Project No. 1339-351-11-02-12
October 18, 2016

Re: Supplemental Submittal
Camelot Landfill Permit Amendment Application – Denton County
Municipal Solid Waste (MSW) Permit No. 1312B
CN600131676/RN101479038

**CAMELOT LANDFILL
CITY OF LEWISVILLE, DENTON COUNTY
TCEQ PERMIT NO. MSW-1312B**

MAJOR PERMIT AMENDMENT APPLICATION

FIGURE 1/II-11.3

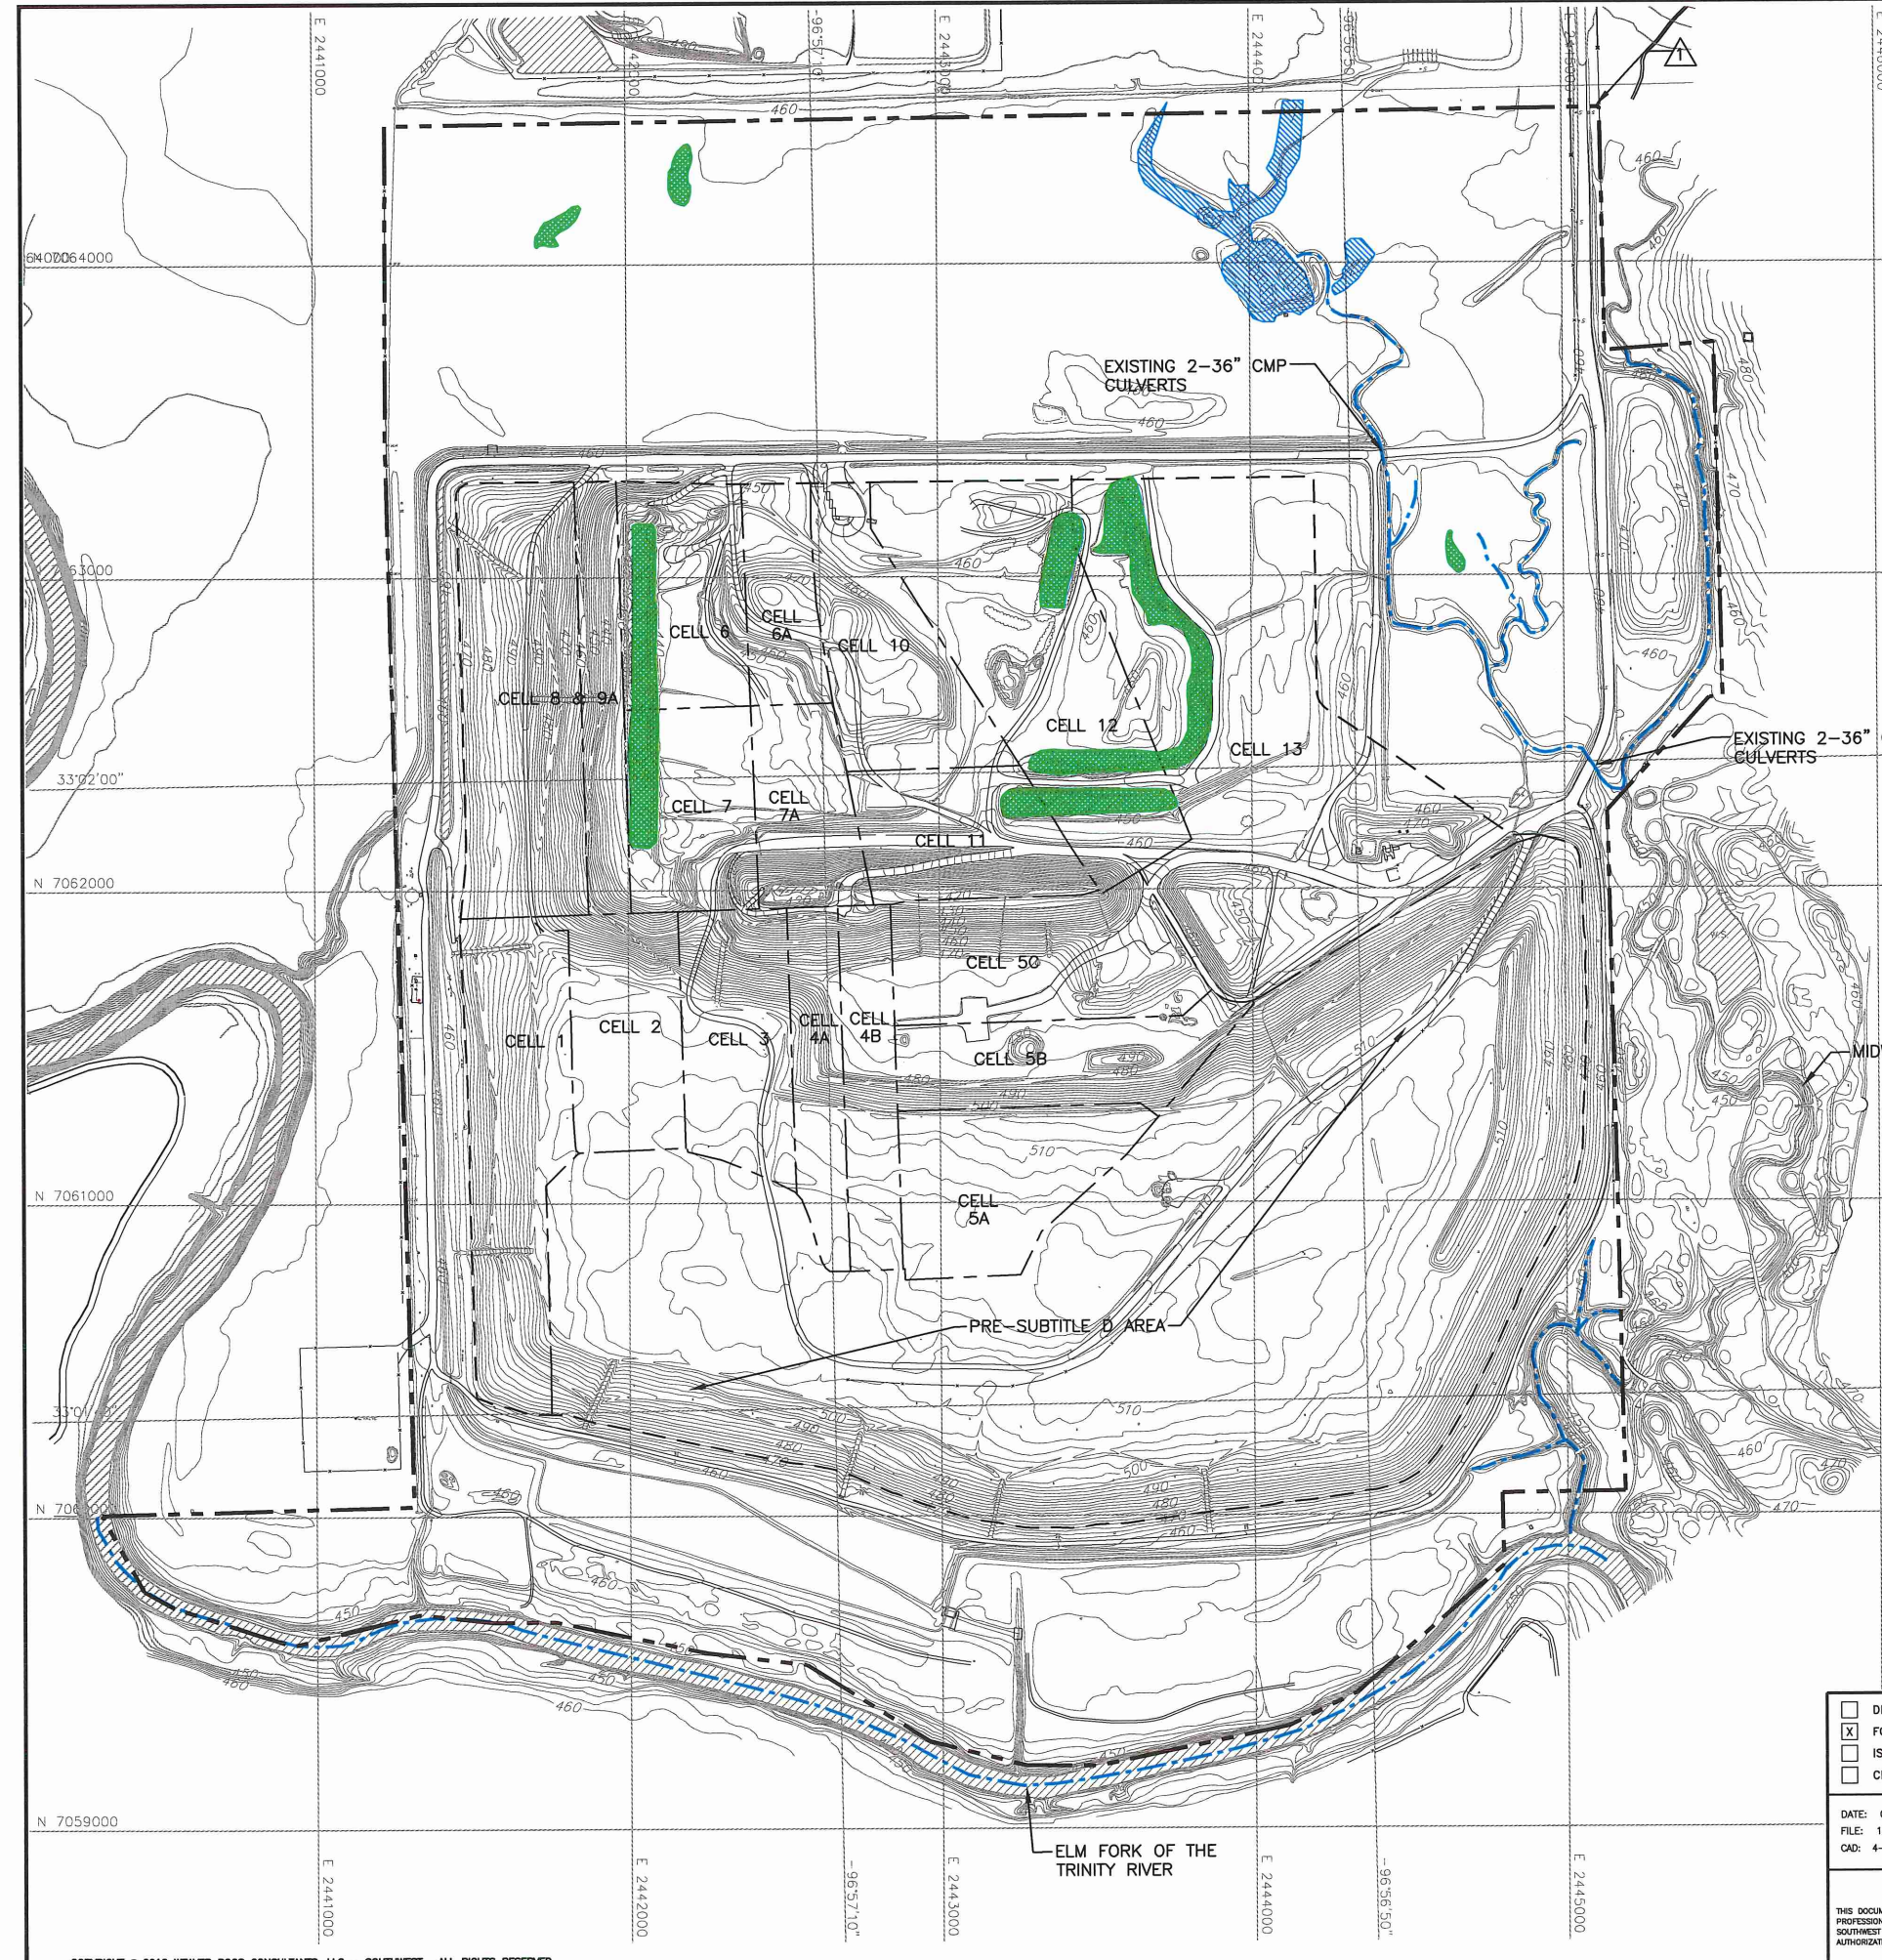
- LIST OF REVISIONS:**
- UPDATED PERMIT BOUNDARY INFORMATION.

TBPE REGISTRATION NO. F-3727 DRAWING A.1

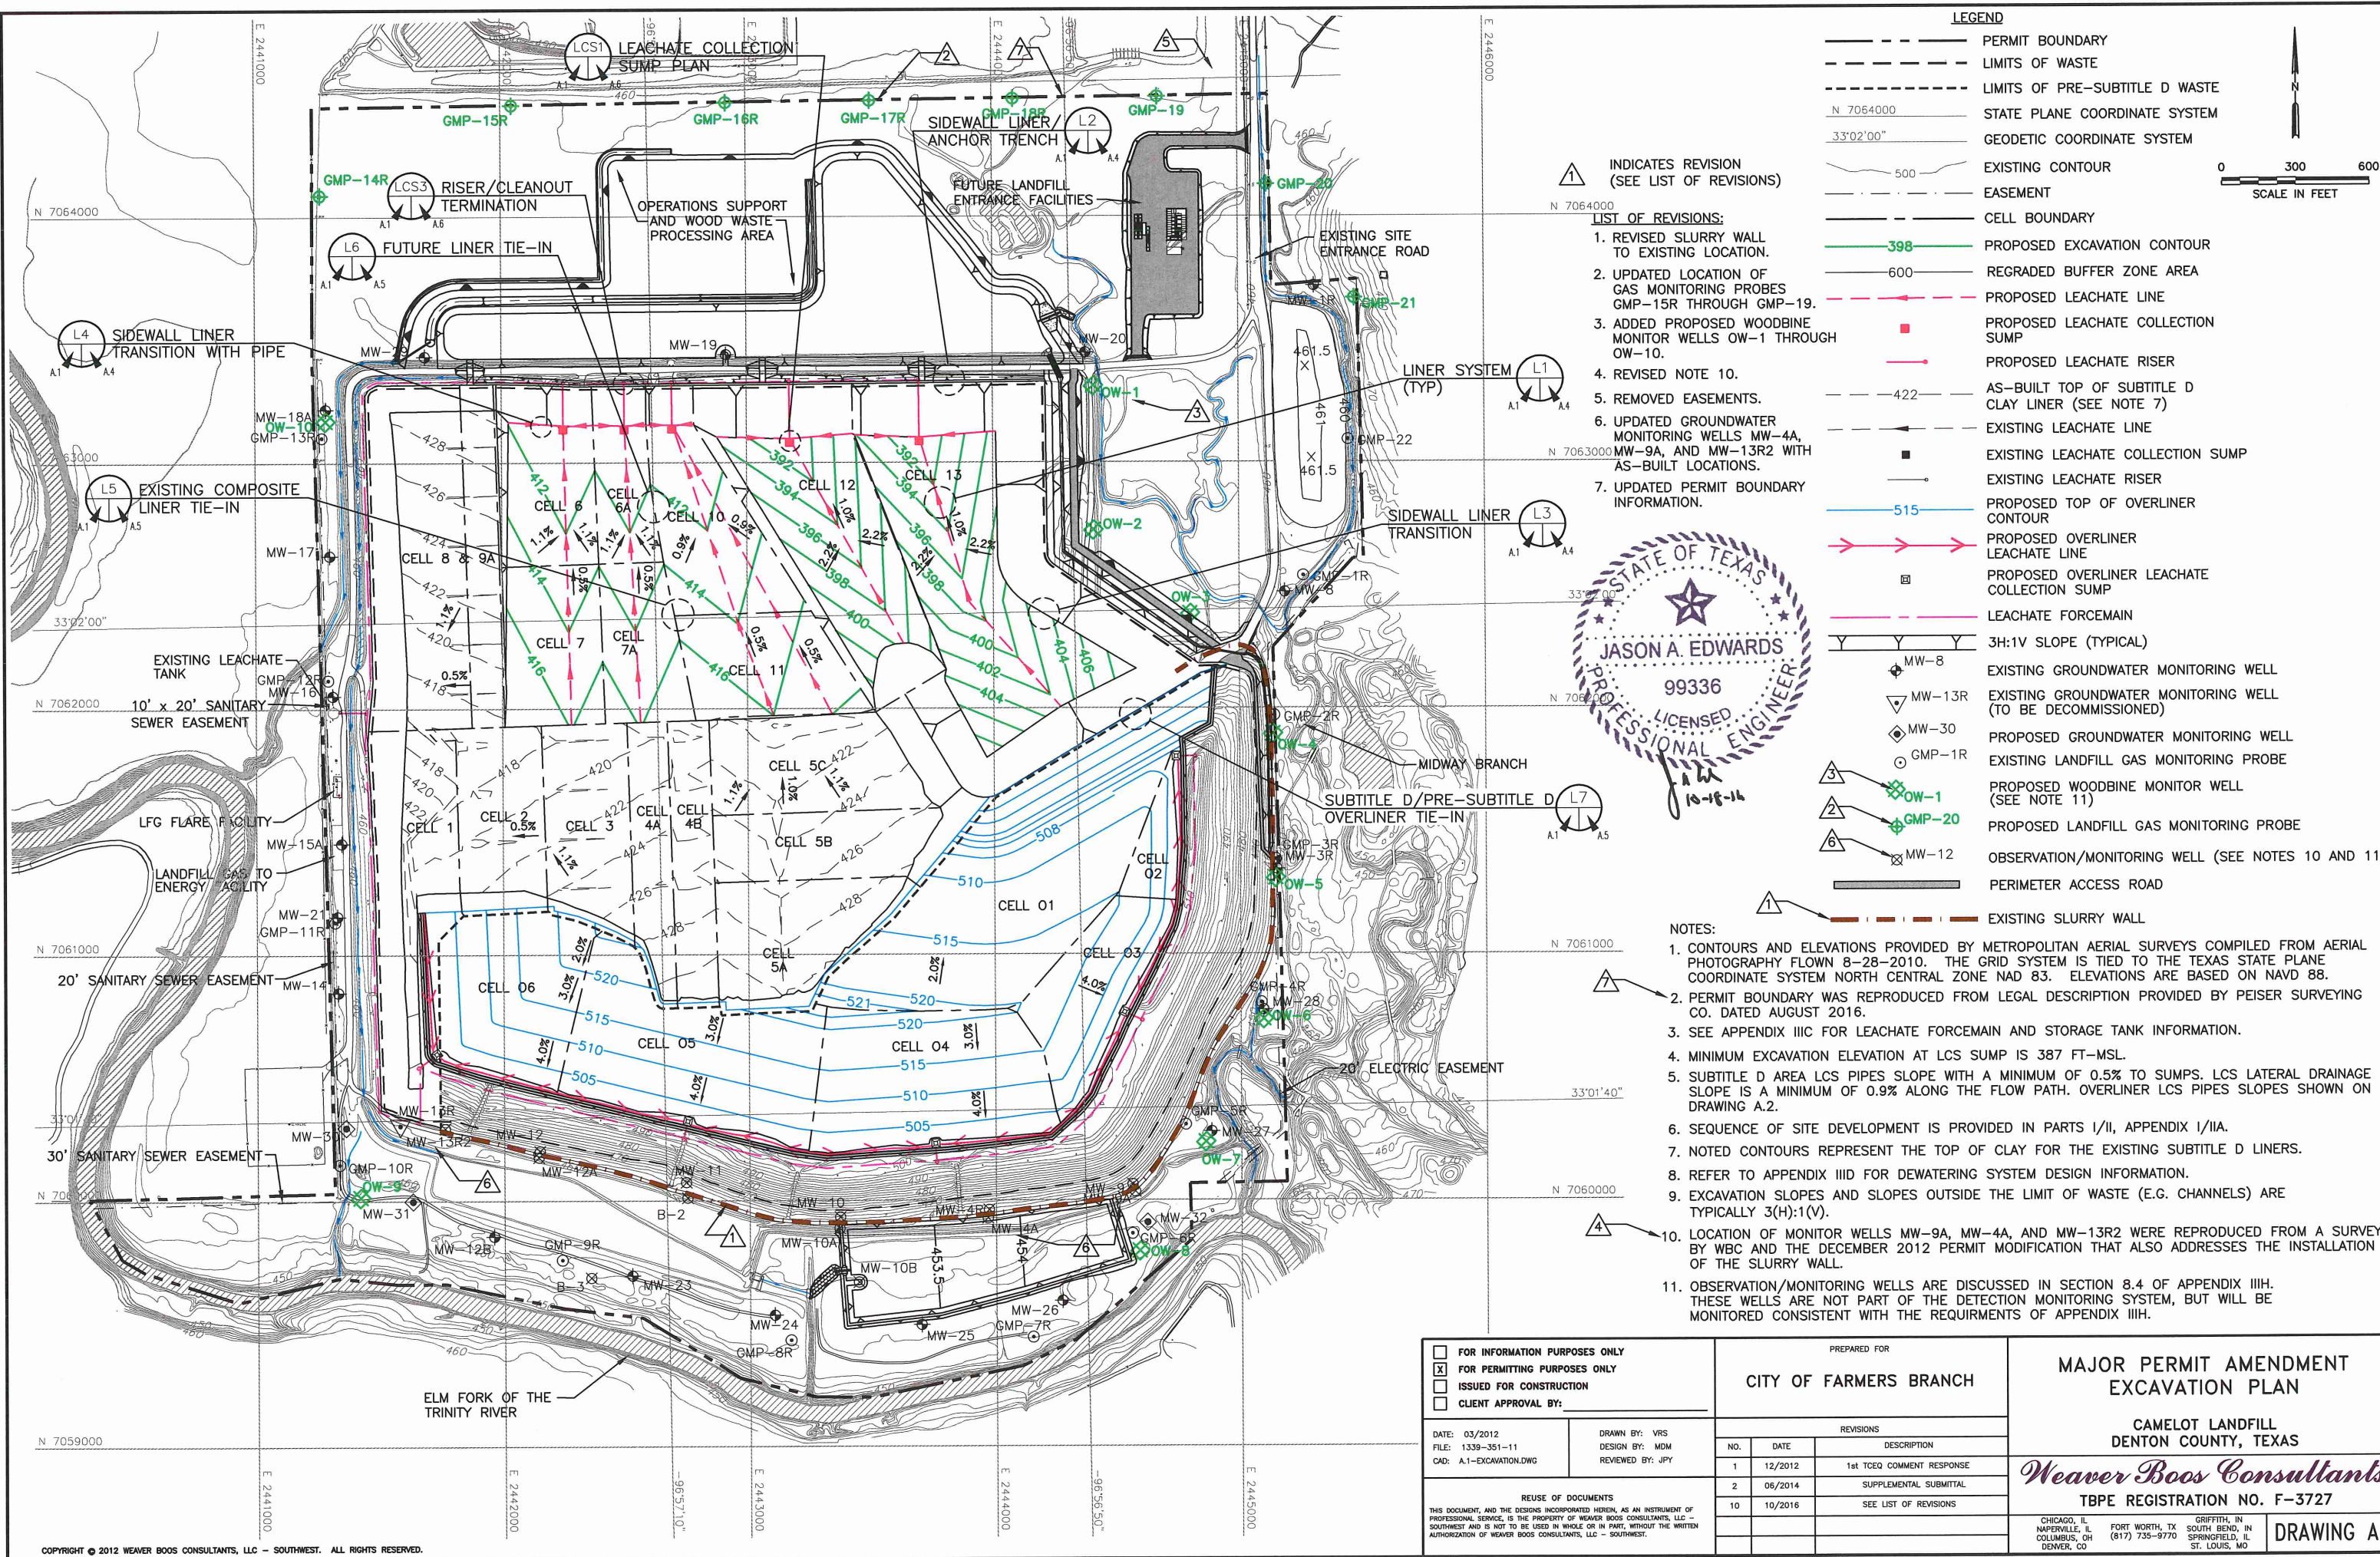
- LIST OF REVISIONS:**
- REVISED SLURRY WALL TO EXISTING LOCATION.
 - UPDATED LOCATION OF GAS MONITORING PROBES GMP-15R THROUGH GMP-19.
 - ADDED PROPOSED WOODBINE MONITOR WELLS OW-1 THROUGH OW-10.
 - REVISED NOTE 10.
 - REMOVED EASEMENTS.
 - UPDATED GROUNDWATER MONITORING WELLS MW-4A, MW-9A, AND MW-13R2 WITH AS-BUILT LOCATIONS.
 - UPDATED PERMIT BOUNDARY INFORMATION.

COPYRIGHT © 2012 WEAVER BOOS CONSULTANTS, LLC - SOUTHWEST. ALL RIGHTS RESERVED.		WEAVER BOOS CONSULTANTS TBPE REGISTRATION NO. F-3727		DRAWING A.3

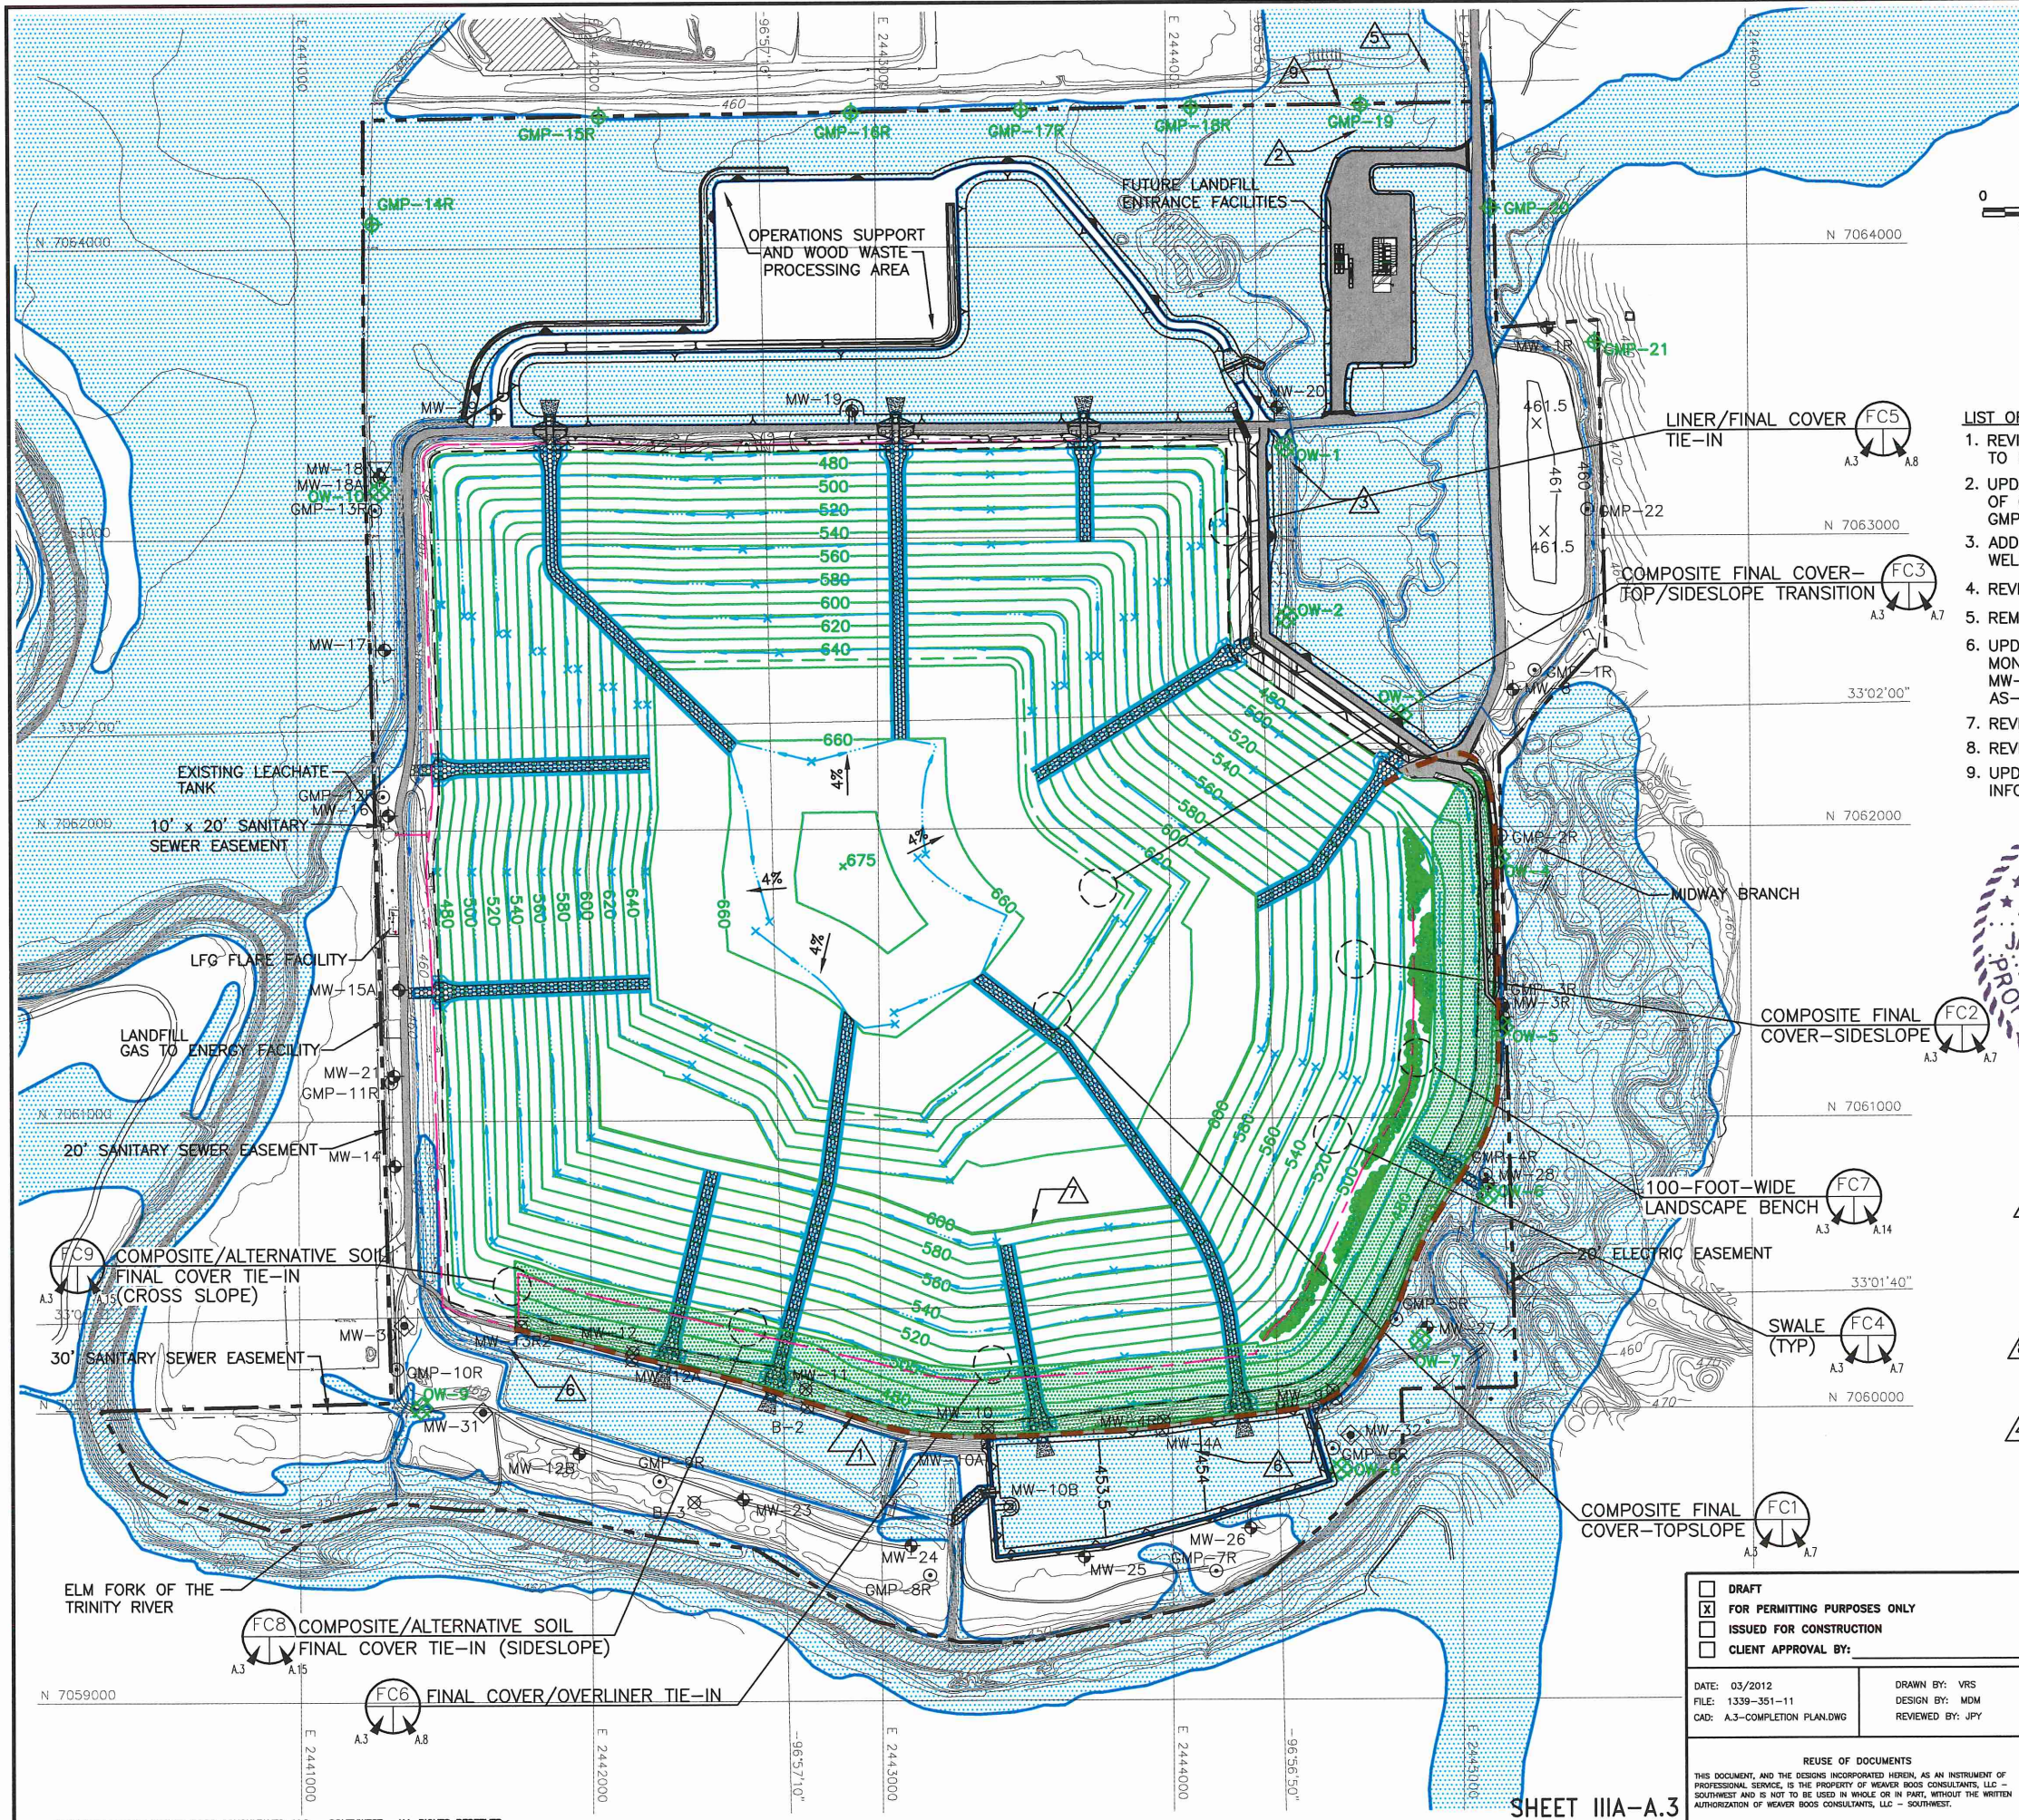
- REVISED SLURRY WALL TO EXISTING LOCATION.
- UPDATED PROPOSED LOCATION OF GAS MONITORING PROBES GMP-15R THROUGH GMP-19.
- ADDED PROPOSED MONITOR WELLS OW-1 THROUGH OW-10.
- REVISED NOTE 8.
- REMOVED EASEMENTS.
- UPDATED GROUNDWATER MONITORING WELLS MW-4A, MW-9A, AND MW-13R2 WITH AS-BUILT LOCATIONS.
- REVISED FINAL COVER CONTOURS.
- REVISED NOTE 5.
- UPDATED PERMIT BOUNDARY INFORMATION.
